REMARKS

VERSION WITH MARKINGS TO SHOW CHANGES MADE²

Response to Office Action - 20 - 09/450,385

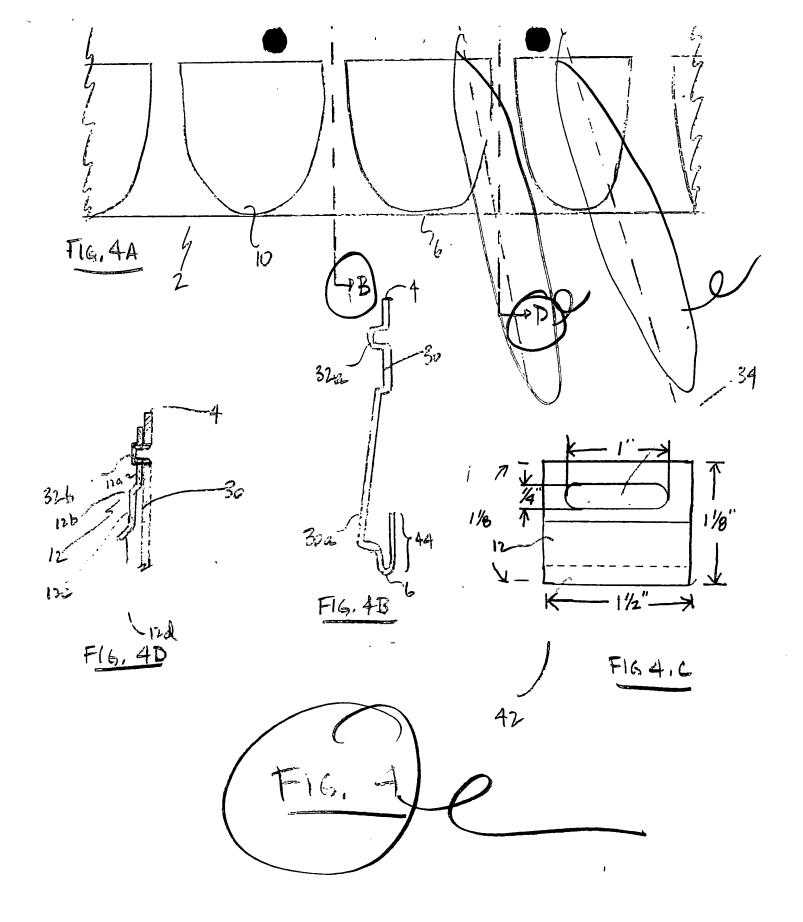
- FIG. 1 has been amended, as shown, to reflect cross-section 6A to 6A.
- FIG. 2 has been amended, as shown, to reflect cross-section 6b to 6b.

- FIG. 3 has been amended, as shown, to show stops 16a and 20a.
- FIG. 4A has been amended, as shown, to show cross sections B to B and D to D, eliminating reference to "FIG. 4," eliminating connectivity to FIG. 4c, and placing it on a separate page.
 - FIG. 4B has been amended, as shown, by placing it on a separate page.
 - FIG. 4C has been amended, as shown, by placing it on a separate page.
 - FIG. 4D has been amended, as shown, by placing it on a separate page.
- FIG. 6A and FIG. 6B have been amended, as shown, by changing the word "PANAL" to "PANEL."
 - FIG. 7 has been amended, as shown, to conform lettering.
